Application No.: 09/994,693

For: OPTICAL PICKUP DEVICE WITH
EXTERNAL PHOTODETECTING
UNIT (as amended)

SUBMISSION OF REPLACEMENT DRAWINGS

Fig. 1

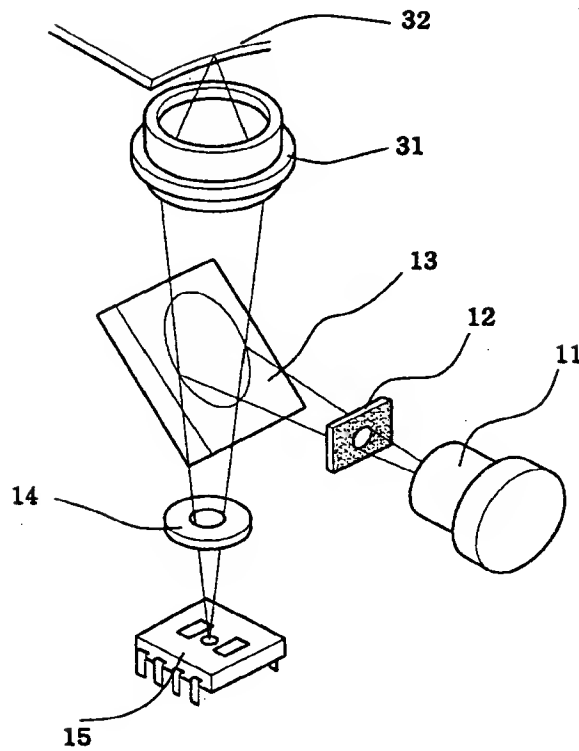
A Submission of Replacement Drawing Sheets is filed concurrently herewith, to add the legend "Prior Art" to Figures 1 and 2. Figure 3 has been amended in accordance with the Examiner's suggestion to change the designator of the substrate for the detecting unit from "126" to
